1. Minutes of Meetings

Dam Discussion by Balai Teknik Bendungan

**TECHNICAL DISCUSSION ON THE CONSTRUCTION OF THE TEMEF DAM, TIMOR
TENGGAH SELATAN AND MANIKIN DAM, KUPANG REGENCY, EAST NUSA
TENGGARARA PROVINCE**

**MINUTES OF TECHNICAL DISCUSSION PRE-PLINARY OF DAM SAFETY
COMMISSION
DISCUSSION OF CONSTRUCTION IMPLEMENTATION AND INITIAL FILLING
READINESS OF AMERORO DAM RESERVOIR**

Figure 5: Longitudinal cross-section of the spillway structure

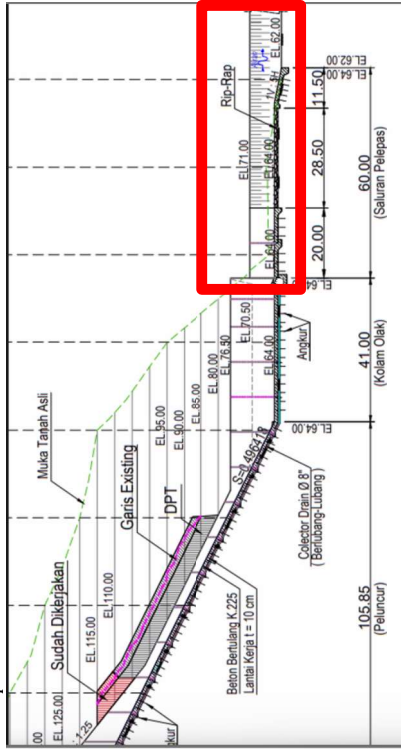
2. With the design of the spillway structure presented, it appears that there is no stilling basin, so it is estimated that the energy of the water flow from the launch channel when it reaches the end sill is still high.
 - a. If possible, consider having the end sill upstream equipped with groundills or concrete blocks.
 - b. In the longitudinal cross-section of the spillway structure, the water flow profile should be depicted based on the results of the test model.
 - c. It is reported that the spillway construction has reached the end sill, so to increase energy absorption, a 3-5 m high embankment/revetment construction will be added

downstream of the end sill. To evaluate the safety of the structure, the connection details between the existing structure and the structure to be added should be reported.

- It is reported that the physical hydraulic modeling of the spillway structure was only carried out up to the Q5 return flood. In accordance with the Guidelines for Designing Embankment Dams Volume IV (1999), physical hydraulic modeling should be carried out up to Q100 in the stilling basin and Q1000 in the launch channel, so that areas in the spillway structure that have the potential to experience cavitation can be evaluated, so that they can be anticipated with design changes or reinforcement.

Figure 6: Cross-section of the v-notch design of the Ameroro Dam

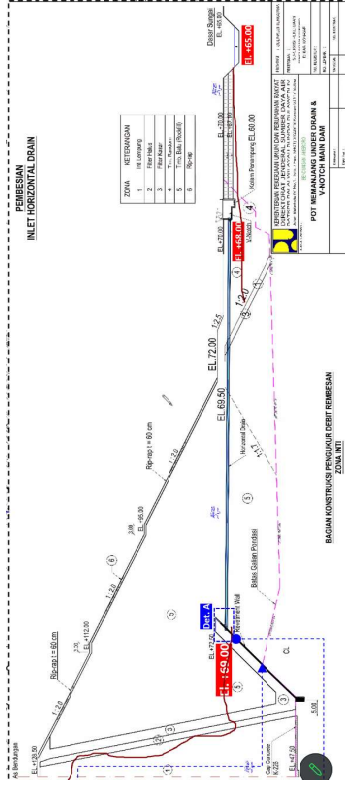
- In the v-notch image presented, it can be seen that downstream of the seepage reservoir before the river, a fill construction has been made which is intended to prevent backwater from the river towards the v-notch.
 - Check the design considerations considering that the river elevation is below the elevation of the reservoir, which is feared to cause seepage to not be able to flow from the reservoir to the river.
 - The influence of embankments downstream of the seepage reservoir on the phreatic water conditions in the downstream rockfill zone should be analyzed. In this case, a comparison should be made between the safety factors in conditions with and without embankments downstream of the seepage reservoir.

Figure 7: Results of back analysis in determining the secant modulus value of the Ameroro Dam

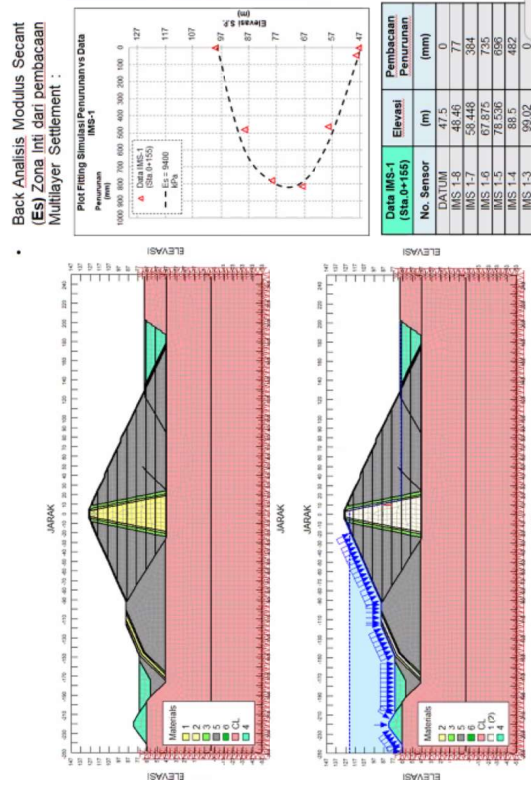
1. In the Ameroro Dam rockfill parameters used in the analysis model, the consultant used correlation parameters that were back analyzed and obtained the secant modulus (ES) value. A large scale triaxial test should be carried out to obtain the secant modulus (ES) value according to field conditions. Then, compare the secant modulus (ES) value and determine the results.

Figure 1: Seepage near V-notch.

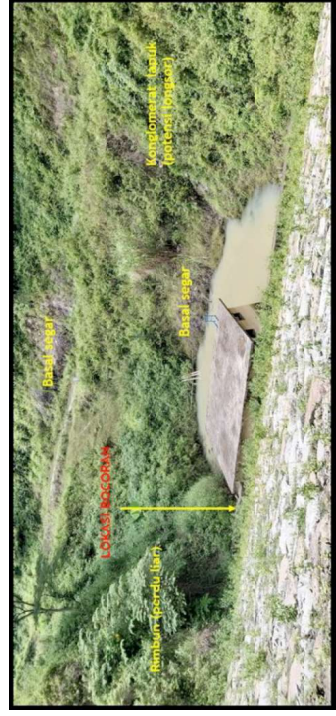
- Observations show leaks around the V-notch and on the right abutment of the dam.
- Action Required: A detailed analysis of seepage conditions supported by data needs to be conducted. It is also necessary to determine whether this seepage poses a safety risk to the dam structure.
-

Figure 5. Example of Numbering Symbols on Pieces E-E'

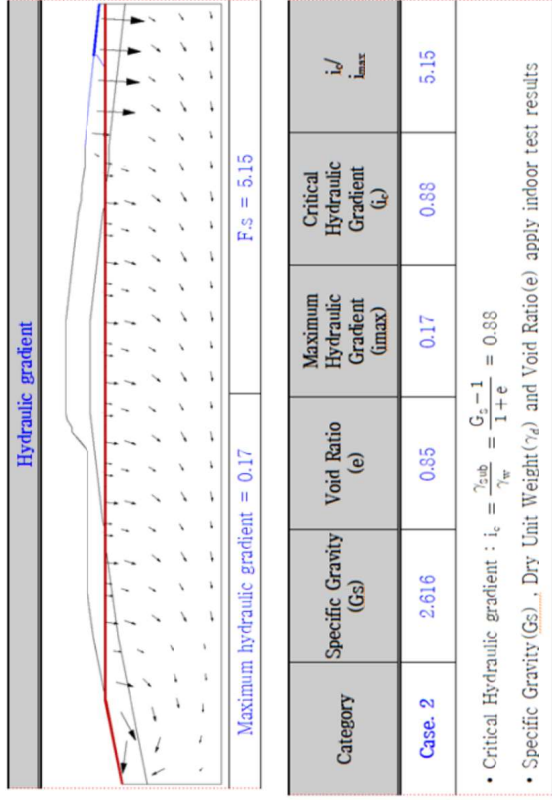
1. The design layout map for the Sepaku Semoi Dam WTP has been submitted (Figure 1), and its sections are (Figure 2, Figure 3, Figure 4).
 - a. It appears that the layout map and the cut do not match. For example, in the E-E' cut, there are circular buildings on the layout map that are not depicted on the cut. According to the Consultant, this is because these buildings were planned to be built after the WTP was operational (Phase 2 & 3). It should be noted that these buildings will later become a burden that can affect the safety of the dam, so they need to be completely depicted on the layout and cross-section map and taken into account in the stability analysis.
 - b. The cut image should also be equipped with a numbering symbol that is adjusted to the layout image. (see Figure 5).

- c. In the description table, symbols number 14 and 15 are in the form of a chemical injection building and a chemical tank, but the Consultant stated that it is only one

Figure 2. Layout of WTP Plan and Deductions A-A', B-B' and C-C'

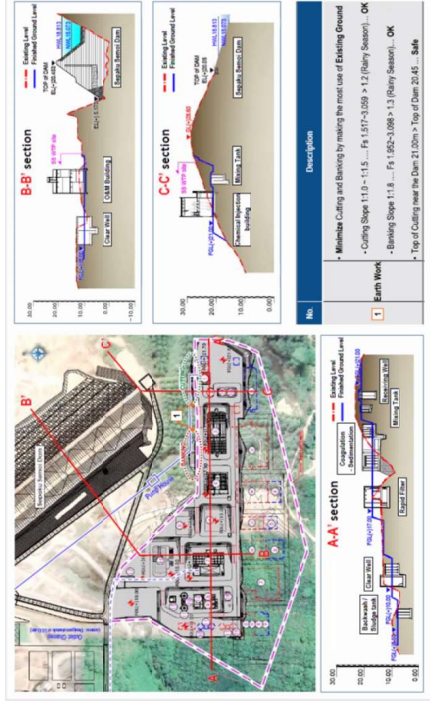
- The WTP is designed to be on the left abutment of the dam, with the distance between the mixing tank (nearest building) to the body of the Sepaku Semoi dam being ± 50 m, and the mixing tank depth is 3.8 m. This distance is considered too close to the dam body, which is feared could compromise the safety of the dam. Apart from that, the left support appears to be a thin hill. For this reason, consider shifting the overall WTP further downstream to ensure it does not affect dam safety. In determining the location of the WTP, you should coordinate with the Kalimantan IV River Regional Office as the Dam Manager.

- In designing the distance of the WTP to the dam body, a seepage analysis should be carried out to ensure the safety of the dam against piping or reed erosion.

- To optimize operational costs for using reservoir water to provide raw water in the future, consider designing the WTP by minimizing the need for pumps and prioritizing the possibility of flowing water by gravity.

Figure 3. Results of Slope Stability Analysis on Section 4 of the WTP Plan

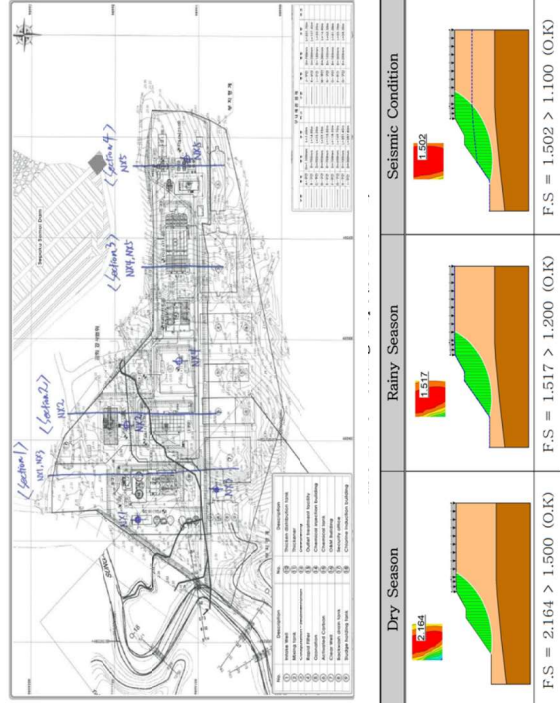
6. The following is Figure 4 and the results of the slope stability analysis of the excavation plan in the Sepaku Semoi Dam WTP planning.
- In the analysis of the slope stability of the excavation plan, it can be seen that the safety factor values obtained are relatively small during the rainy season and during seismic conditions. Detailed calculations for each condition should be provided, both for the stability of the excavation slope and the stability of the embankment slope.

- If the WTP is designed close to the dam body, which is feared to be dangerous to the stability of the dam, dam stability analysis should be carried out by adapting the standards applicable to dams in Indonesia, namely based on effective stress conditions and carried out under several loading conditions including rapid drawdown conditions. Meanwhile, if the WTP is shifted further downstream so that there is no fear of disrupting the safety of the dam, discussions on the WTP design can be continued with the Kalimantan IV River Basin Center as the Dam Manager only, and do not require a recommendation from the Dam Safety Commission.

- c. Analysis needs to be carried out in accordance with actual conditions in the field. For this reason, the engineering parameters (engineering properties) used in the analysis should be based on field tests, and the depiction of the groundwater phreatic line used in the analysis should be presented based on assumptions about normal water conditions, bearing in mind that data regarding the amount of water pressure was not obtained at the time of design, pores in the field are used to delineate the phreatic line.

Figure 4. Aerial Photo of the Condition of the Left Support of the Sepaku Semoi Dam

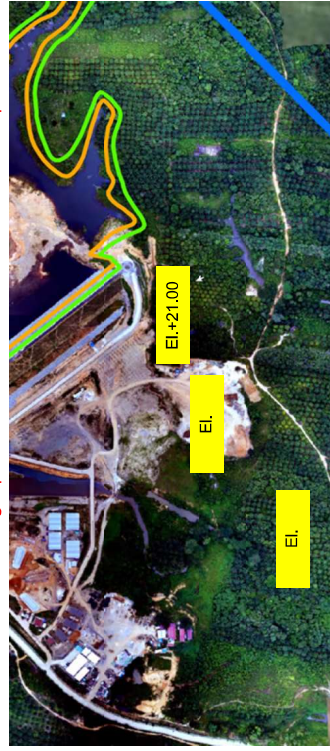
7. In designing the Sepaku Semoi Dam WTP, the consultant should consider the technical suggestions mentioned above and suggestions from the Directorate General of Human Settlements which recommends that the position of the prospective WTP be placed further
